A25368 – 22 & 22A Summit Drive, Mount Albert

RFI Response

CKL Reference	A25368
Filename:	A25368-TR-ITA-RFI Response
Site Location:	22 Summit Drive, Mount Albert
Author:	Chloë Davison Senior Transportation Engineer 
Reviewed and Authorised By:	Judith Matkinson Director 
Revision No.	2
Document Status:	Approved
Date:	15 January 2026

FIGURE 1: LONG SECTION (R/SUB/2016/743)

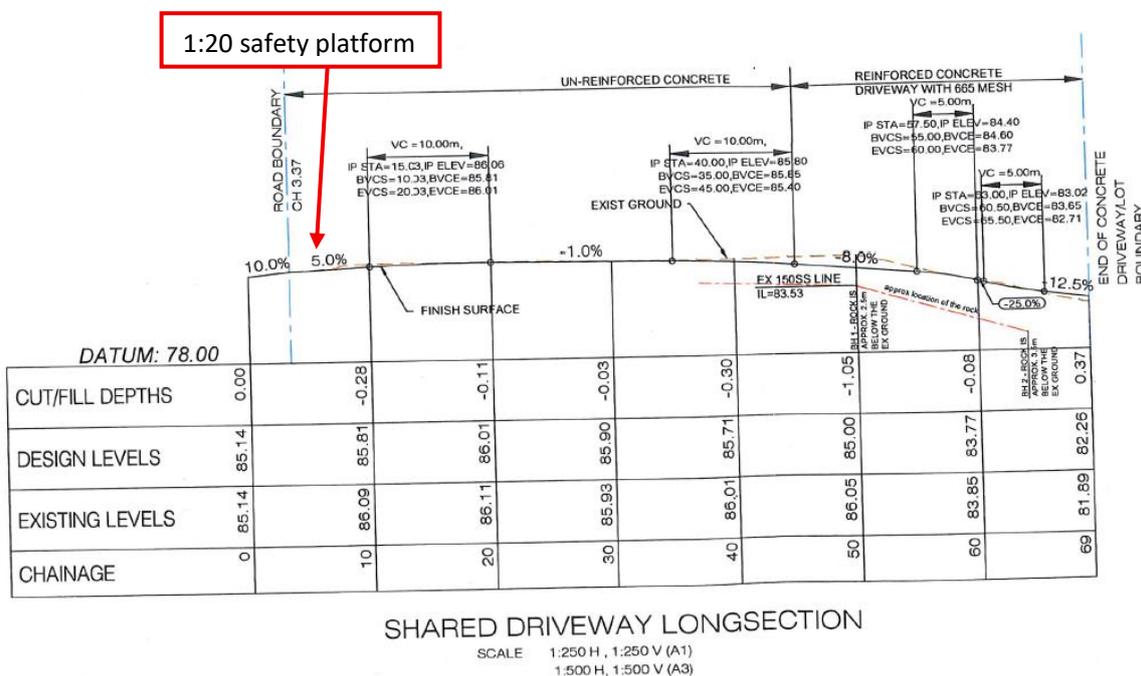
Item 10. Please provide appropriate long sections to verify compliance with the following Auckland Unitary Plan (UP) standards:

- *E27.6.3.6 – Formation and Gradient;*
- *E27.6.4.4(2) – Vehicle Access Transition Gradient; and*
- *E27.6.4.4(3) – Vehicle Access Platform*

The shared driveway was consented and constructed under R/SUB/2016/743 and complied with the standards that applied at the time consent was granted. It is legally established to serve two properties and forms part of the existing environment. No physical changes are proposed to the recently constructed shared access and the proposed scale and intensity is consistent with what was anticipated when subdivision was approved. Accordingly, no formal assessment against any new standards, and no additional reasons for consent under those standards, are required as part of this proposal.

The long section shows gradient, transition sections and a 1:20 access platform. The maximum gradient is -12.5% and as such complies with development control T157 of the Unitary Plan. It is noted that transition sections are not required as the change in gradient is gradual. No grounding or safety issues are expected based on the driveway gradient design.

FIGURE 2: LOT 1 MANOEUVRING GRADIENT

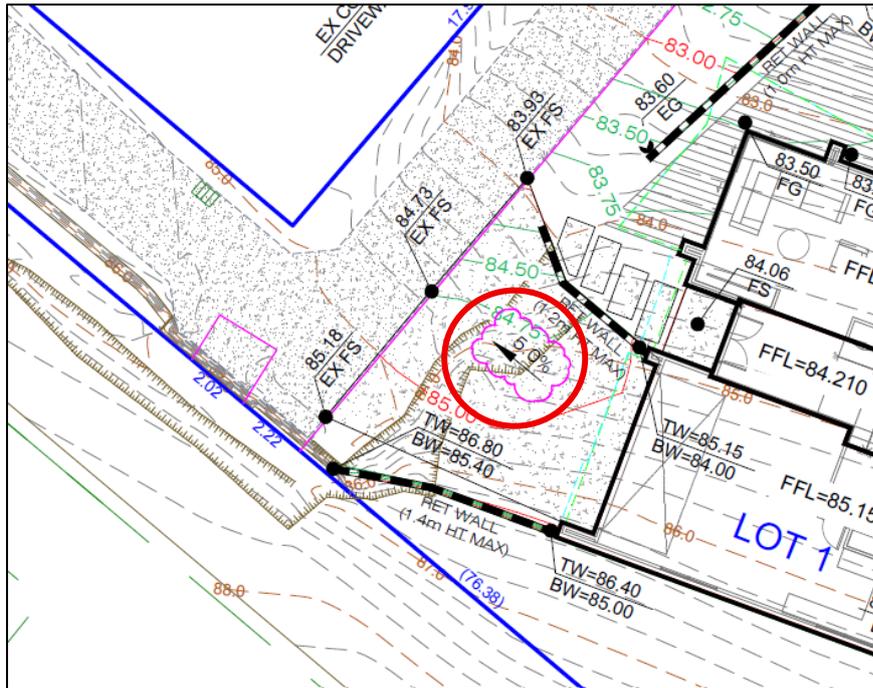
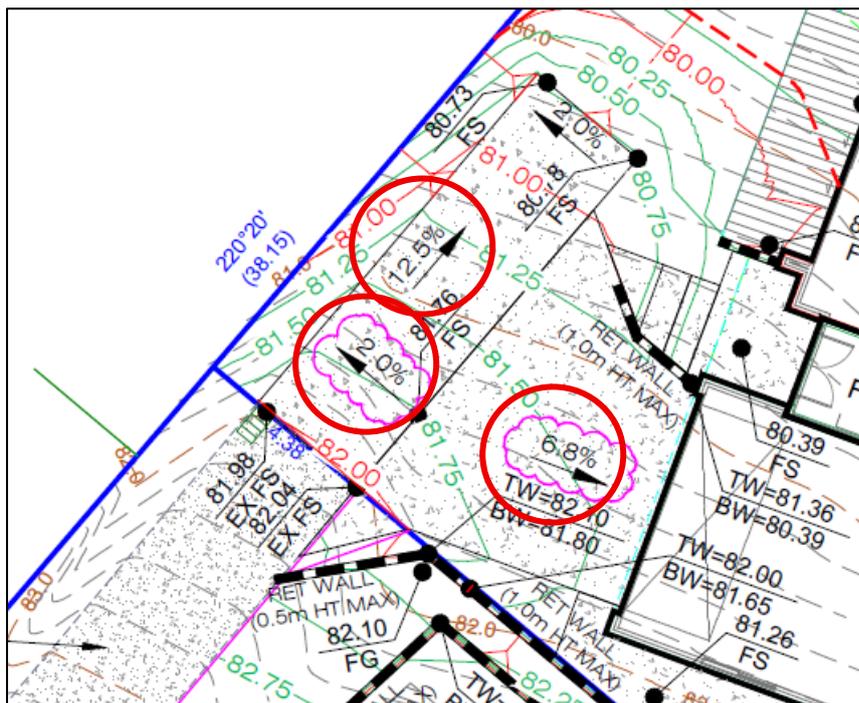
11. Please demonstrate on the plans the proposed surface gradient for the manoeuvring spaces to demonstrate compliance with standard E27.6.3.6 Formation and Gradient.

In accordance with Standard E27.6.3.6, the gradient for manoeuvring area must not exceed 1 in 8 (12.5%). The maximum manoeuvring gradient for Lot 1 is 5% and the maximum manoeuvring gradient for Lot 2 is 12.5% and as such comply with the Unitary Plan requirements.

Refer to the Anchor drawing RC-104 Rev B dated April 2025 and the red ellipses detailed in Figure 2 and Figure 3.

FIGURE 4: LOT 1 ENTRY (WESTERN SPACE)

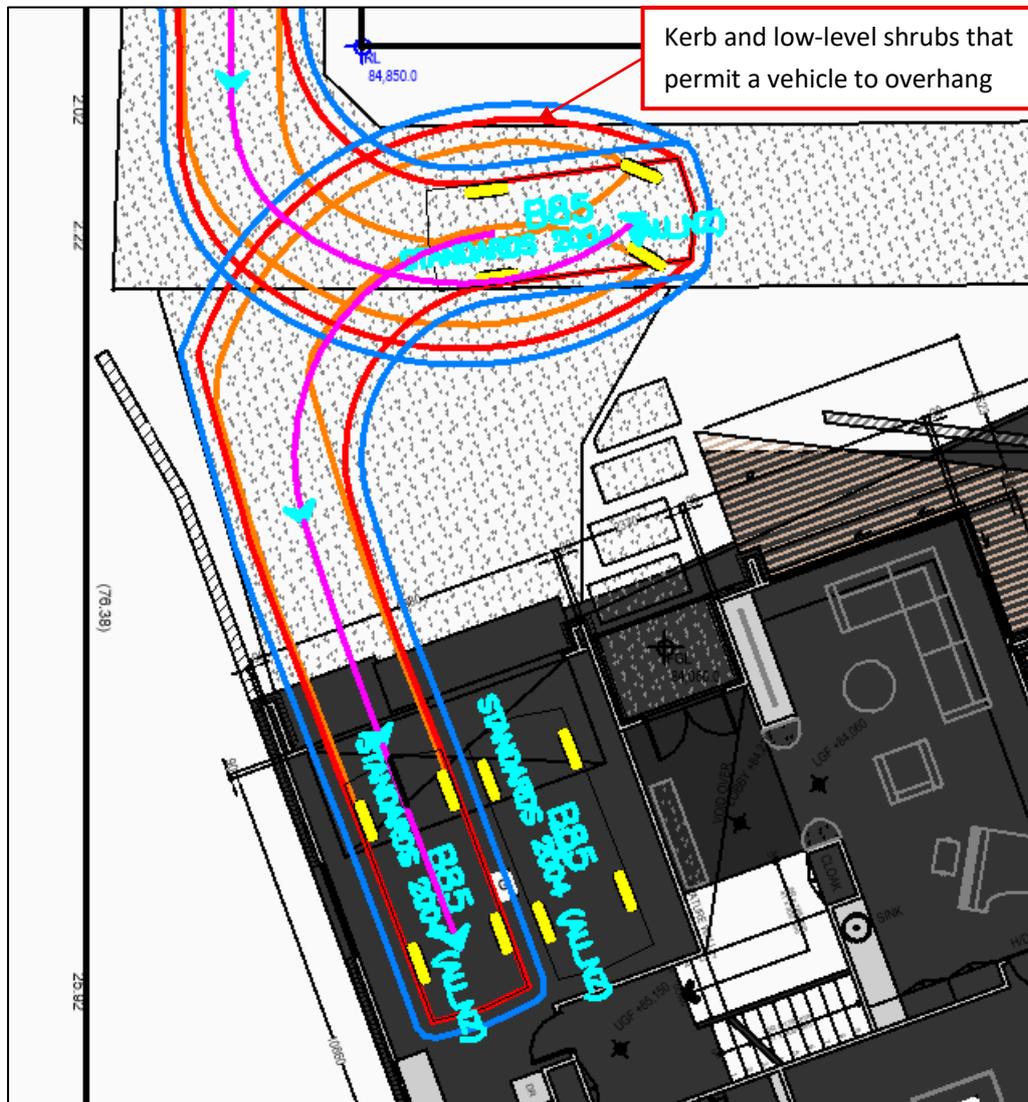
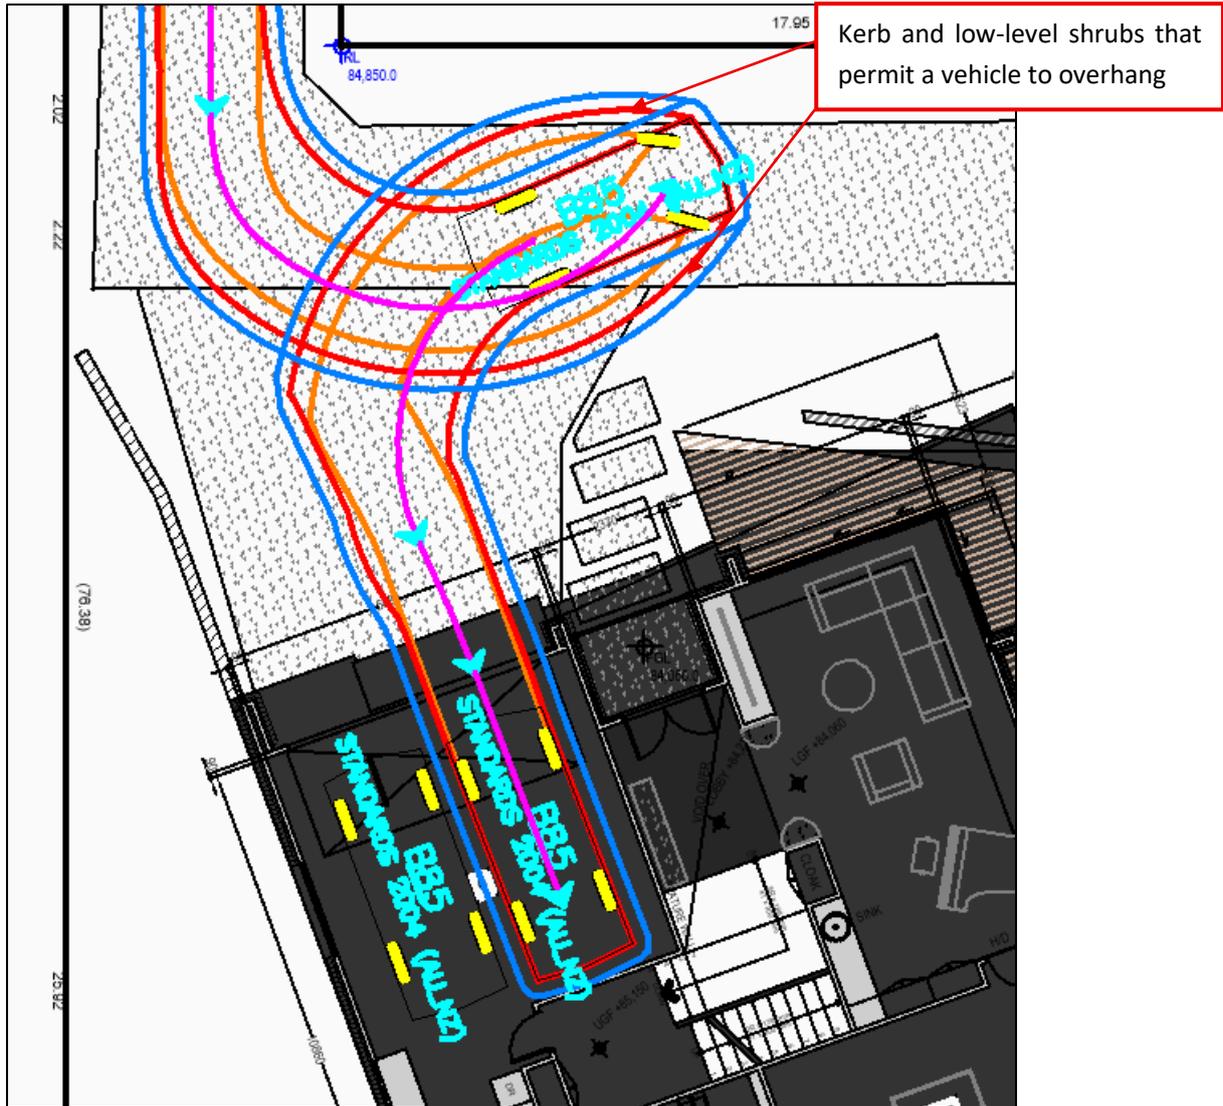
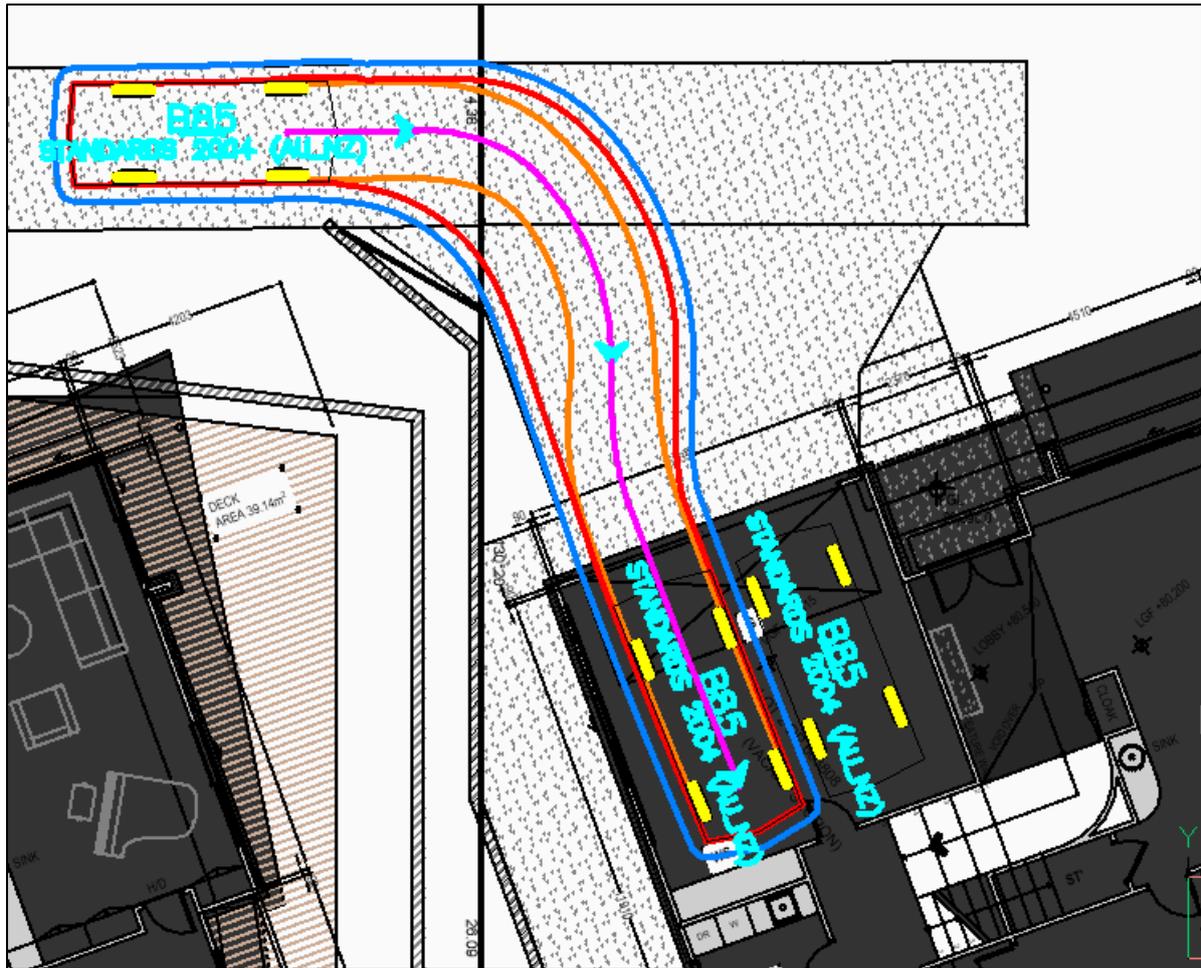
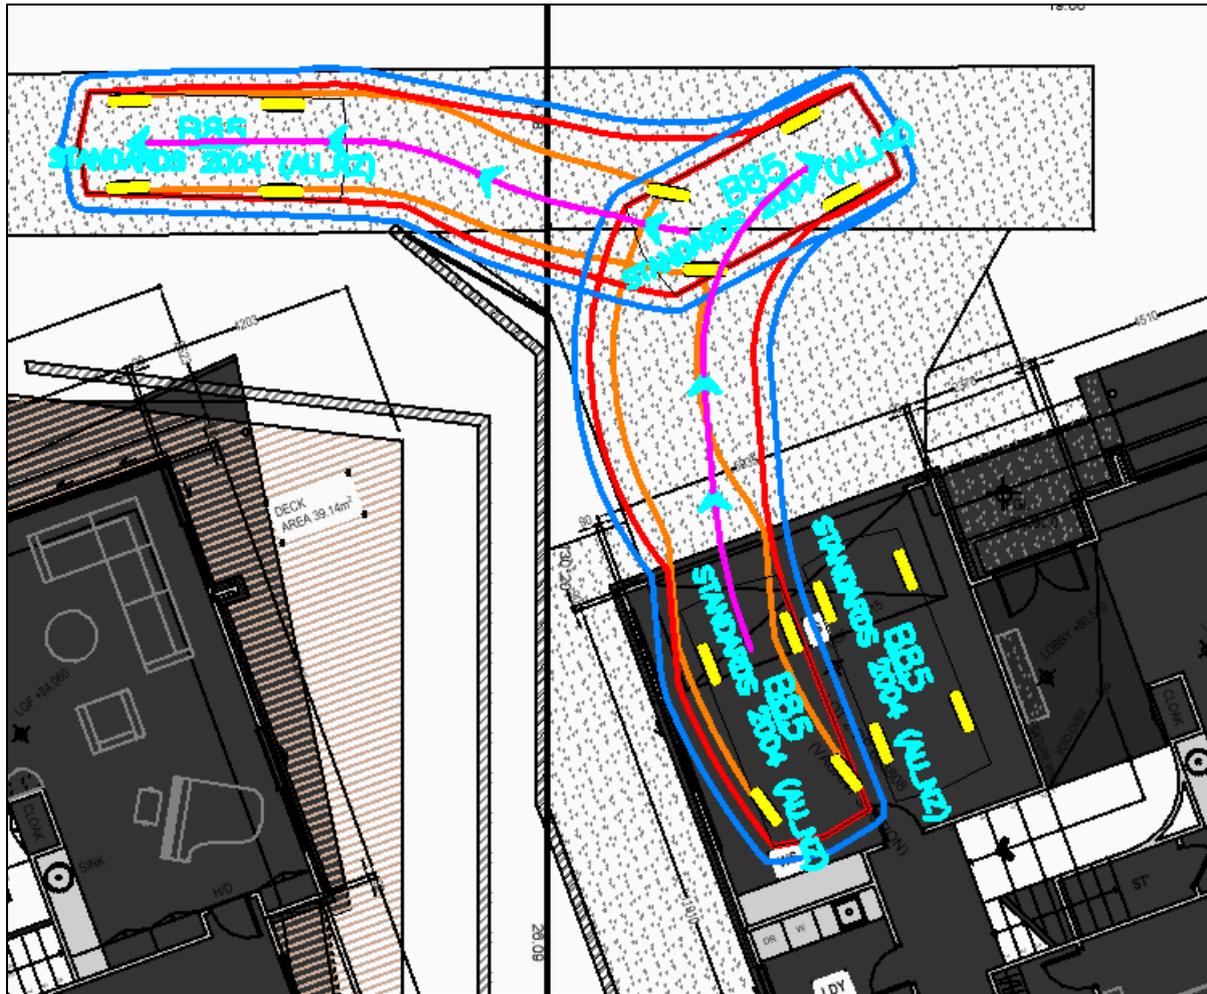
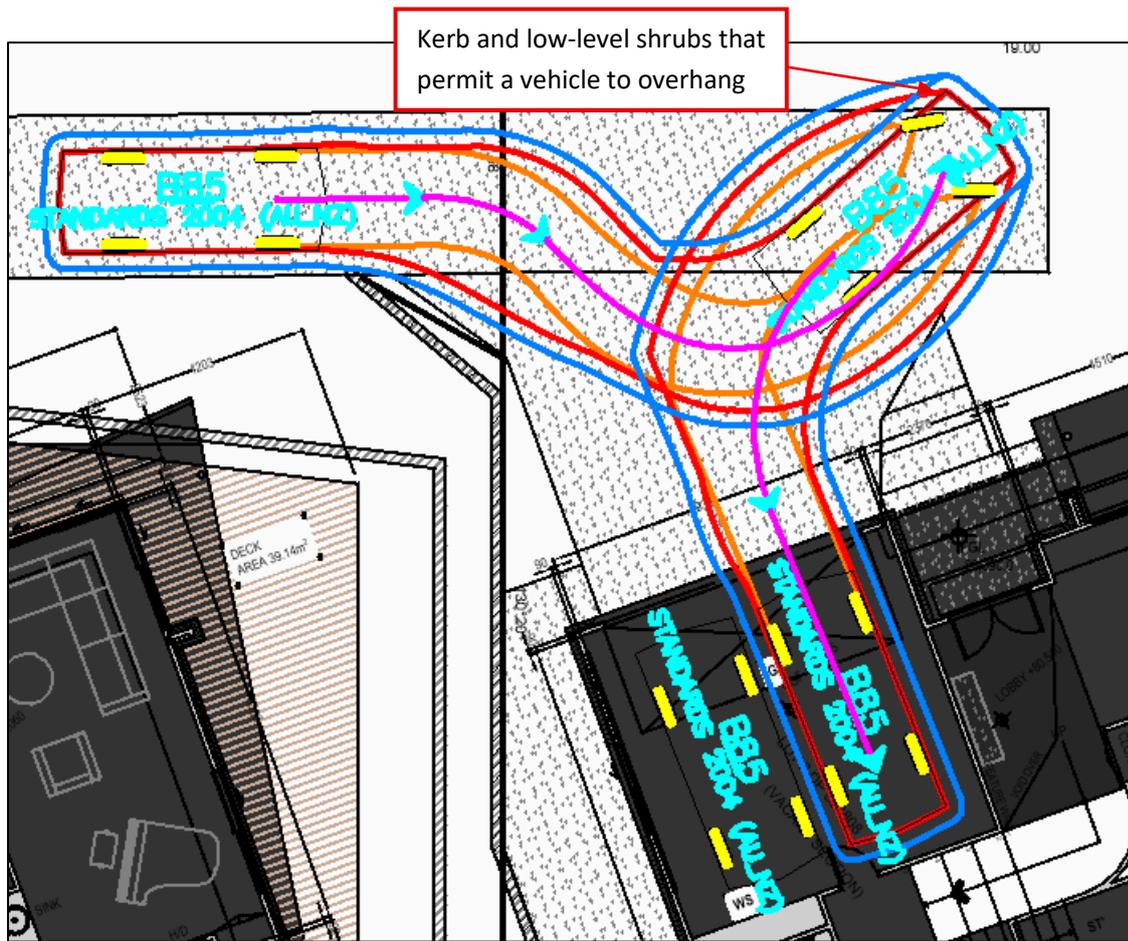
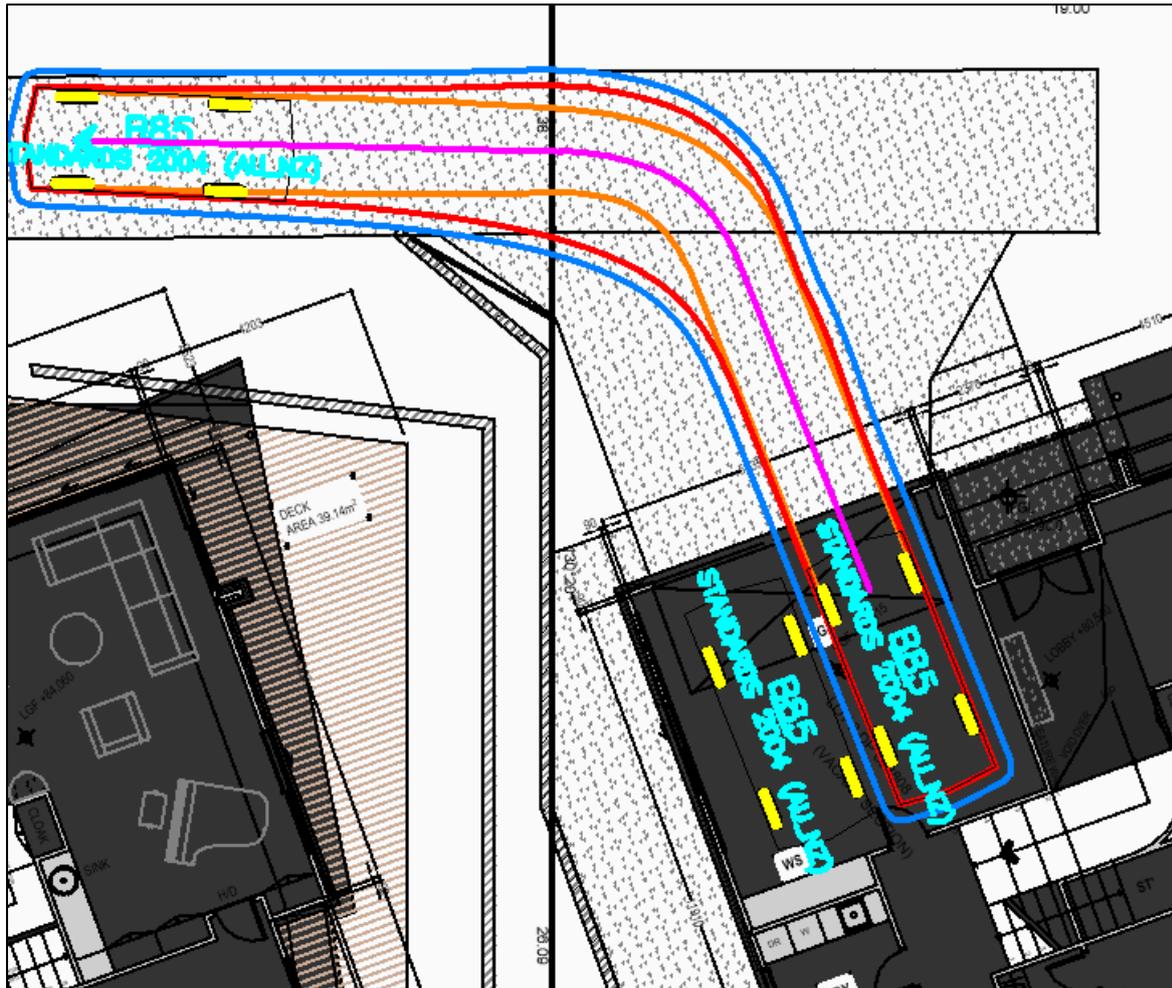
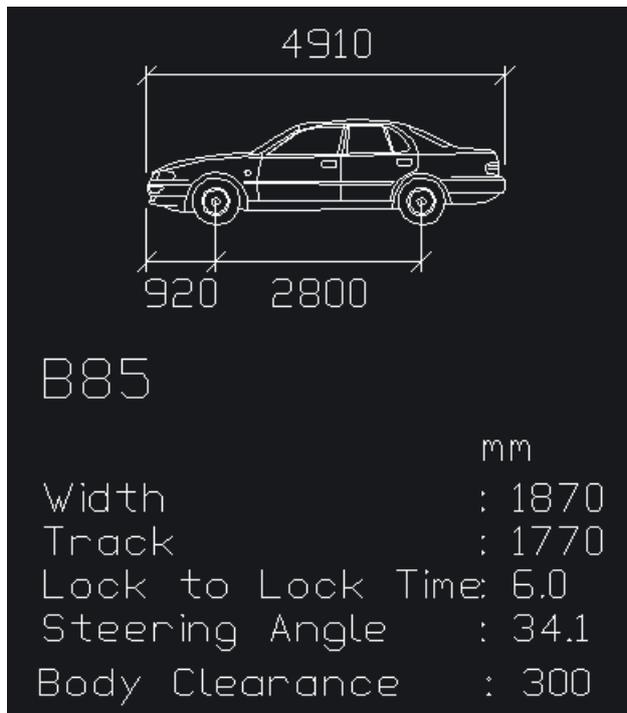
12. Please demonstrate on-site vehicle manoeuvring from all proposed parking spaces. Please provide vehicle tracking curves that clearly specify the design vehicle used, the tire path, vehicle body outline, and a 300mm clearance envelope to demonstrate that the vehicles can safely ingress and egress all parking areas.

Vehicle tracking analysis has been undertaken to demonstrate operational feasibility. A B85 vehicle has been used in accordance with Figure E27.6.3.3.1 of the Unitary Plan. A clearance envelope of 300mm around the vehicle body is shown in blue, the vehicle body is shown in red, and the front wheel tracking

line is shown in orange. As requested, the design vehicle profile is shown in Figure 10. In all instances the wheel lines are contained within the driveway although there are some instances where the bonnet of the vehicle will overhang slightly the kerb and low-level planting. Drivers are able to enter and exit the car parking spaces within the garages, turn around, and leave in a forward's facing direction. No safety or operational issues have been identified based on the vehicle tracking analysis.

Vehicle tracking is shown in Figure 4 to Figure 9.
